**Sent:** 13 February 2026 17:50  
**To:** DC Admin  
**Subject:** Planning objection Application - 2025/60/93572/E  
**Attachments:** STATEMENT OF OBJECTION 130226.pdf; Cumberworth landscape constraints.pdf

**Application Ref:** 2025/60/93572/E

**Proposal:** Outline application (all matters reserved except access) for up to 123 dwellings

**Site:** Upper Cumberworth

# Upper Cumberworth

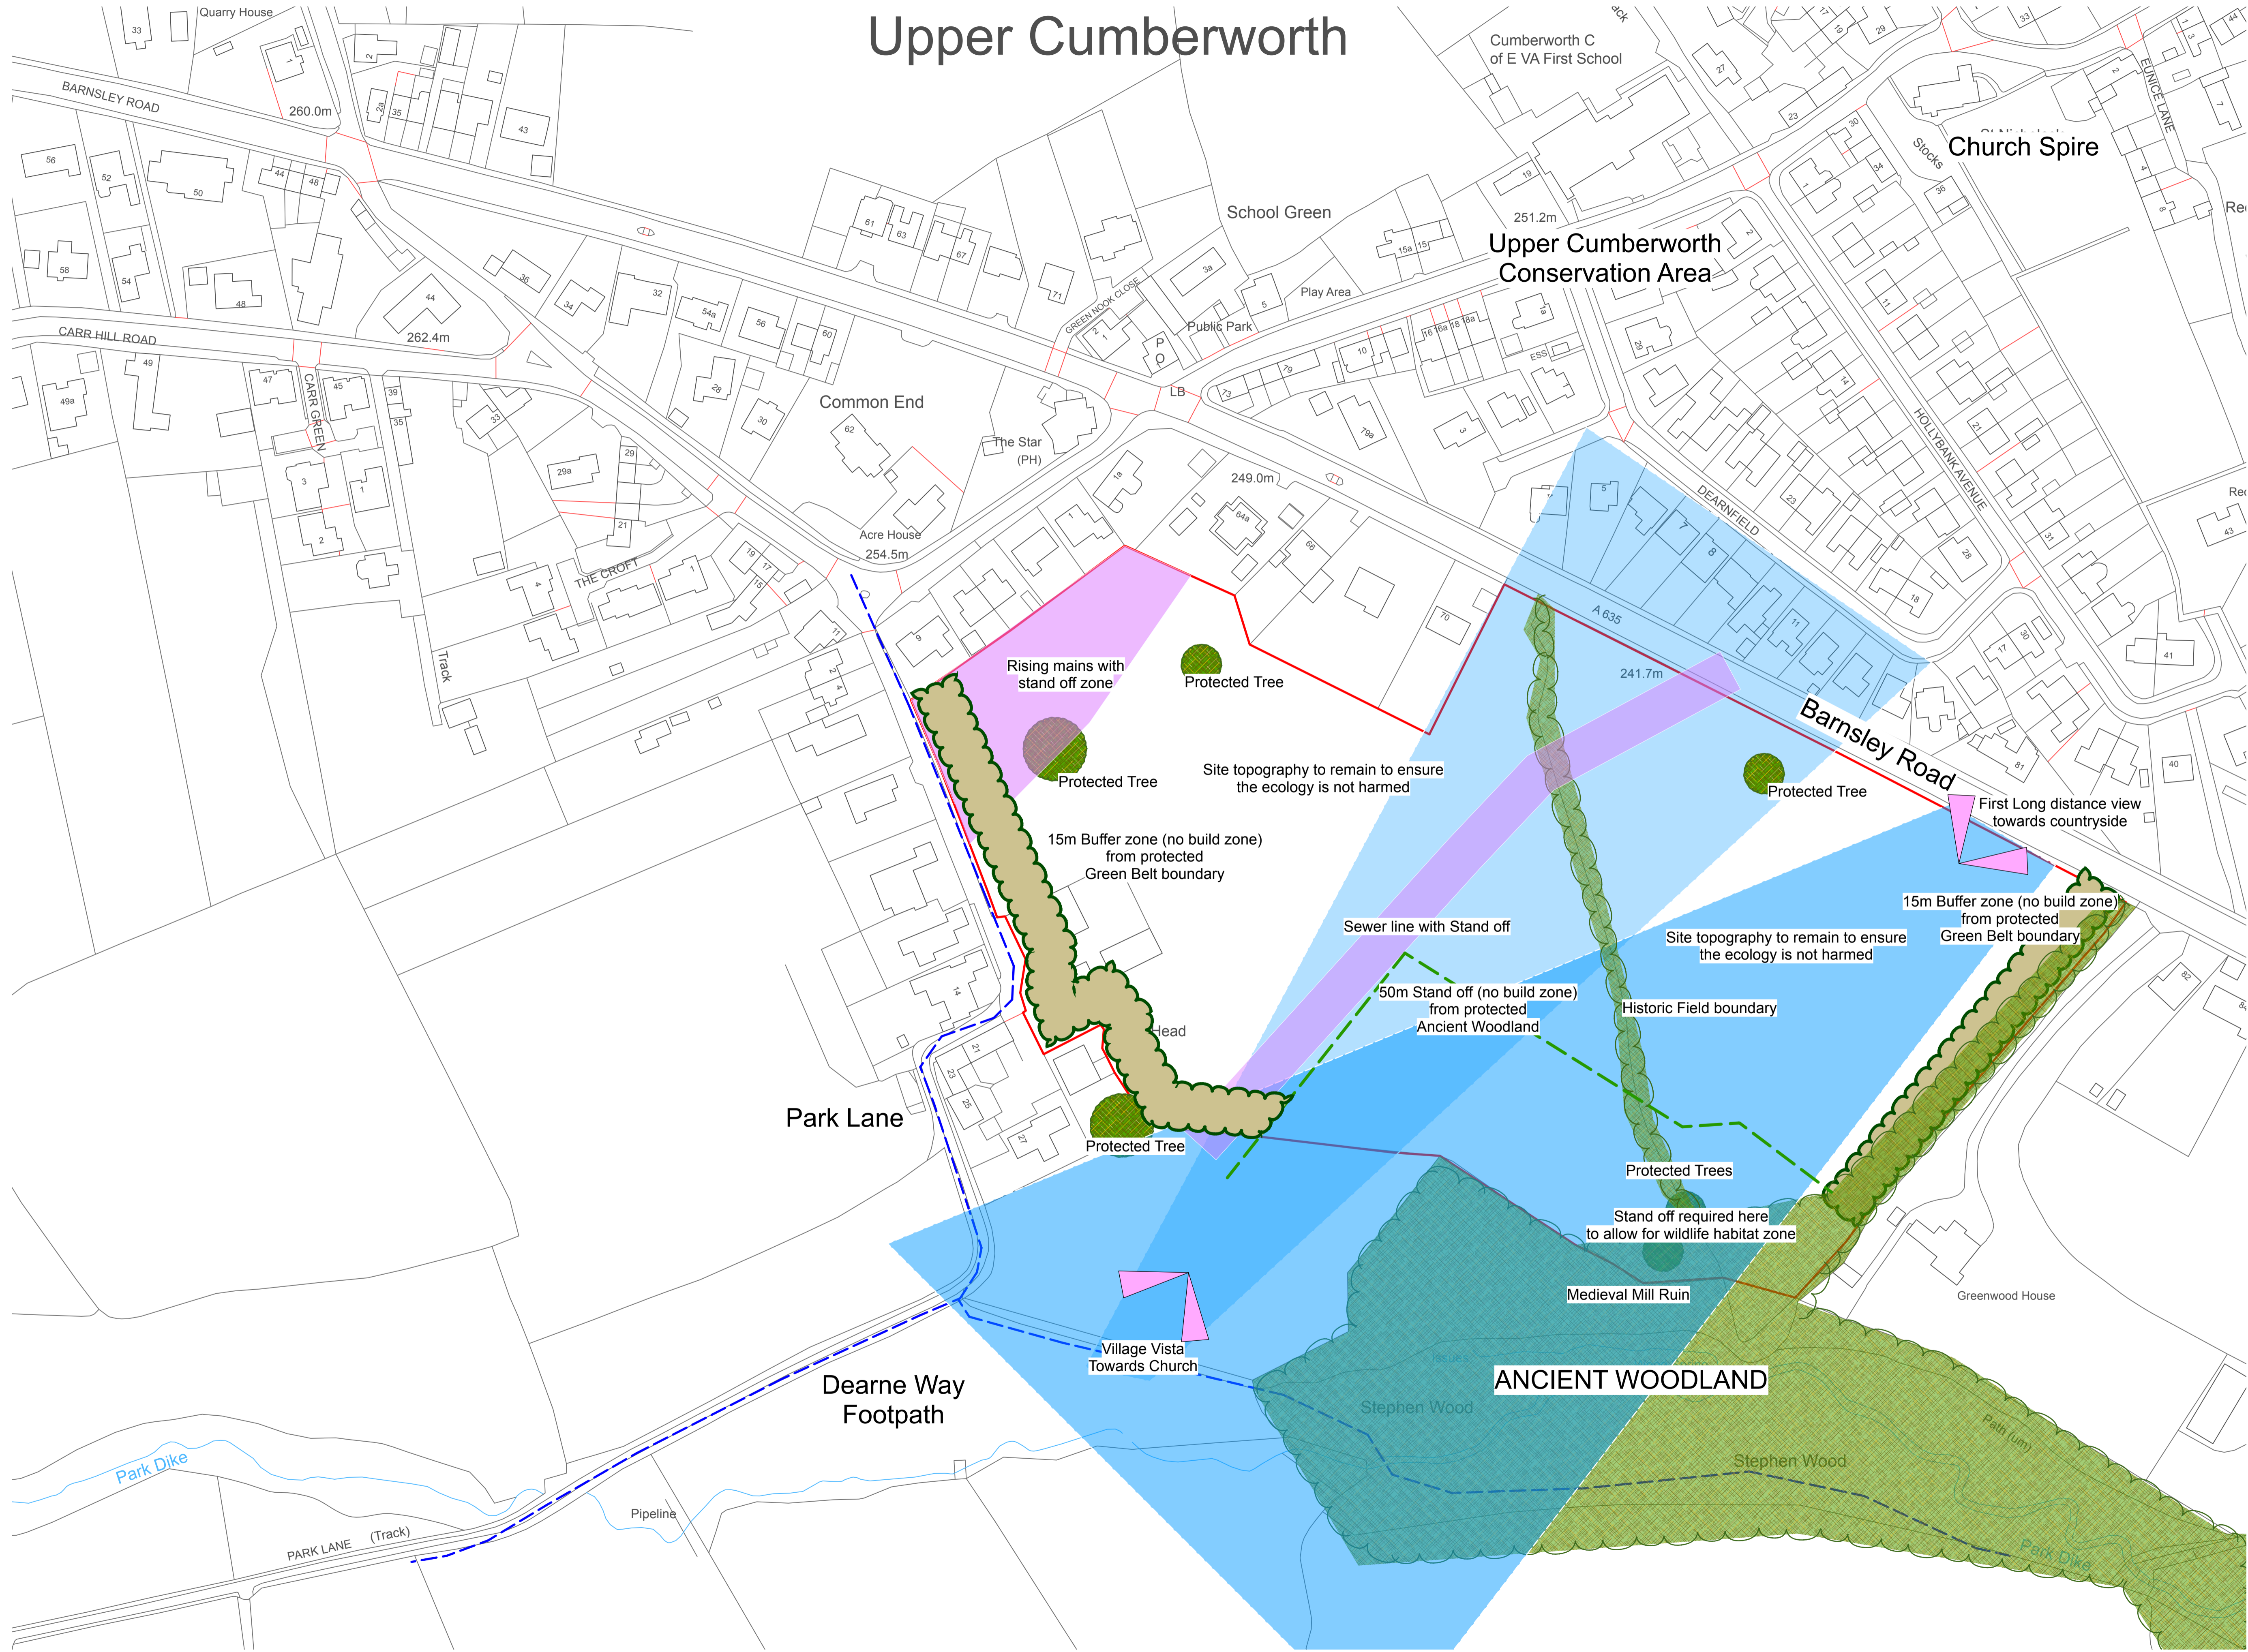
As well as my objection I have also attached a landscape and visual constraints plan which demonstrates how un-suitable development in this area is.

NOTE\_ A landscape constraints plan has been attached for clarity and to demonstrate the fields landscape and visual constraints, which fail to have been identified on the application.

15m Buffer zone (no build zone) from protected Green Belt boundary

50m Stand off (no build zone) from protected Ancient Woodland

Stand off required here to allow for wildlife habitat zone
